Facility Name: Chisholm Trail Disposal Landfill

Re: Chisholm Trail Disposal Landfill

Type IV Municipal Solid Waste Landfill Permit Application

Technical NOD 4, Tracking No. 29623137

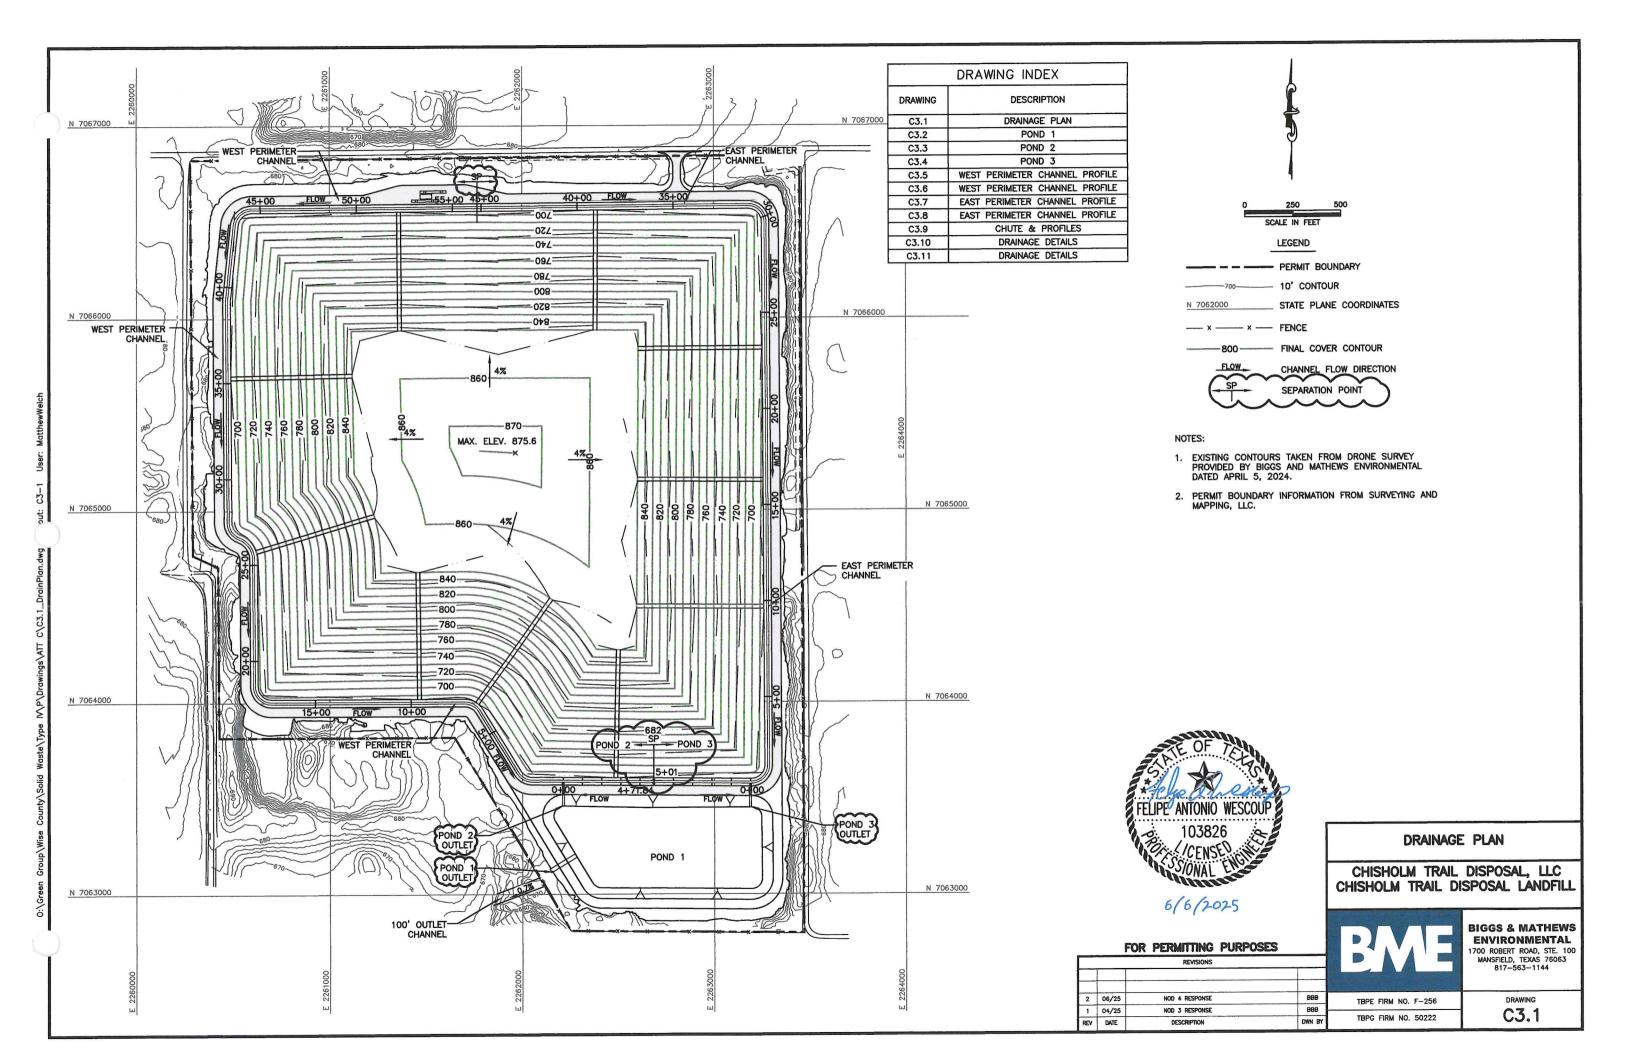
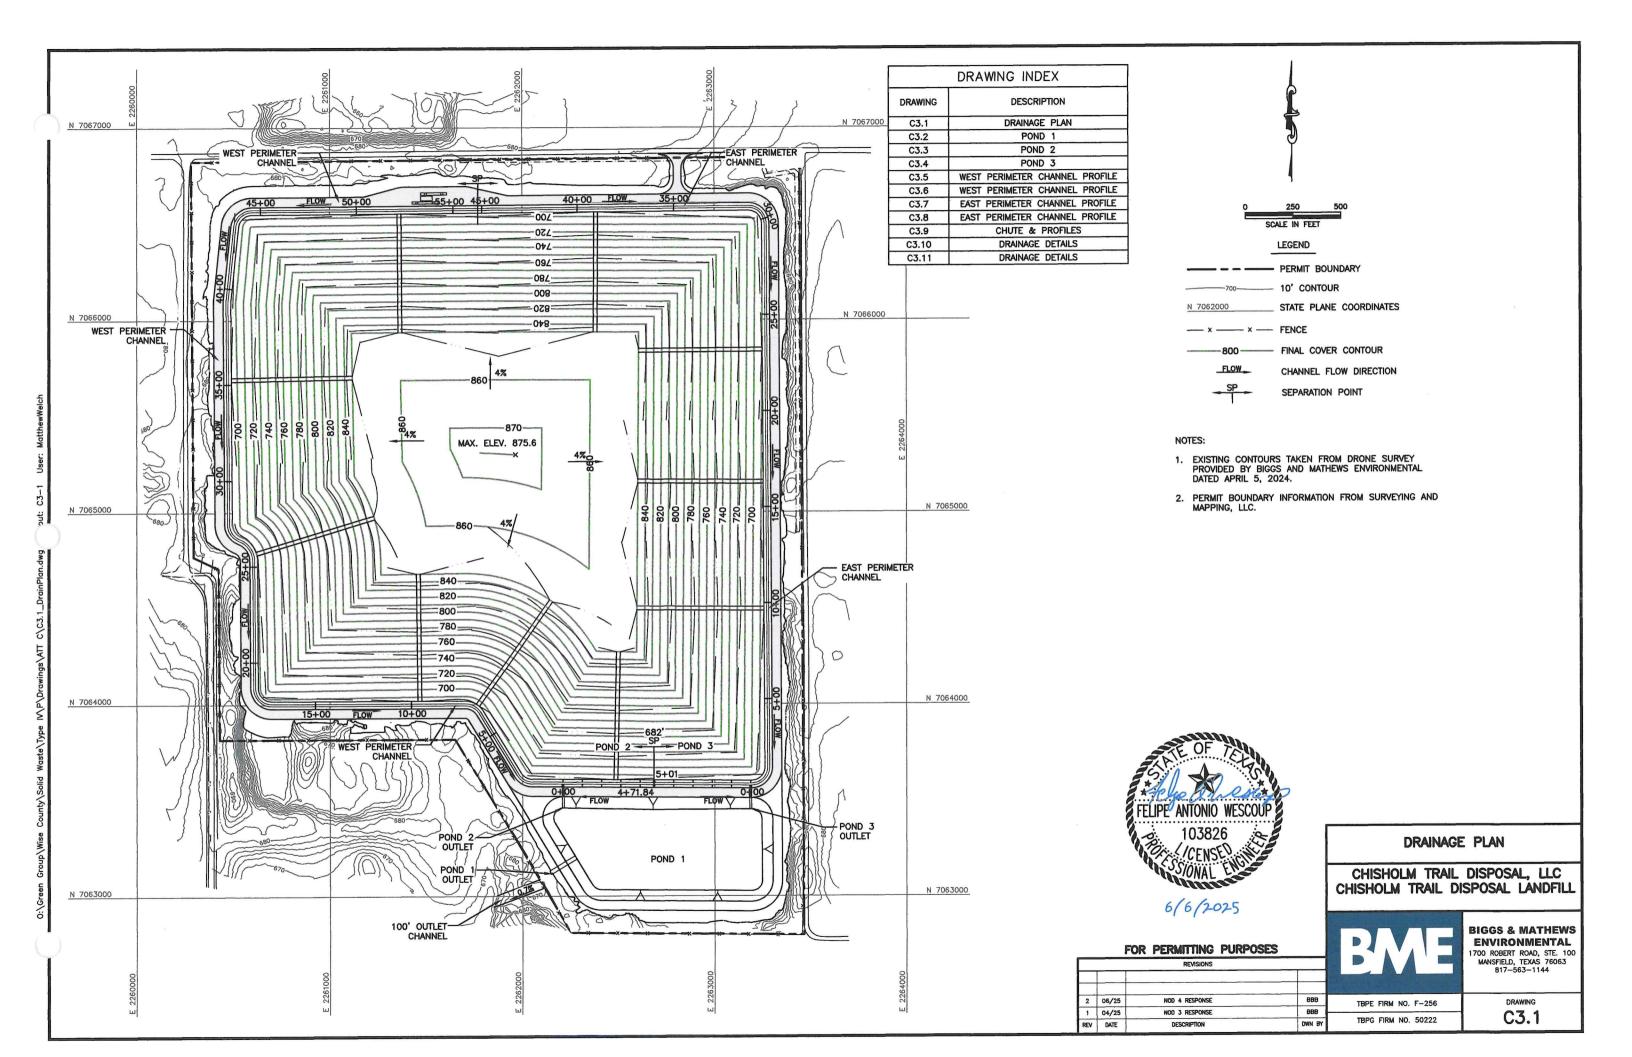
5. In NOD 3 response to comment 12, Drawing C3.1 was revised to add flow directions. The added flow directions in Drawing C3.1 do not indicate the separation between Pond 2 and Pond 3. In response to comment 13.1, Page 1 in Appendix C1D was revised to state that Ponds 2 and 3 transfer water to Pond 1 via culverts. The revised Drawing C3.1 does not show the culverts discharging from Ponds 2 and 3 into Pond 1. Revise Drawing C3.1 to clearly show the ponds' separation point and the culverts/inlets from Ponds 2 and 3 into Pond 1. (It is noted that Drawing C1C.1 marks the Pond 1 outlet.)

RESPONSE: Drawing C3.1 has been revised to more clearly show the separation point between Ponds 2 and 3 and to show the culverts/inlets from Ponds 2 and 3 into Pond 1. The revised drawing now provides the complete hydraulic connectivity between the detention ponds as requested.
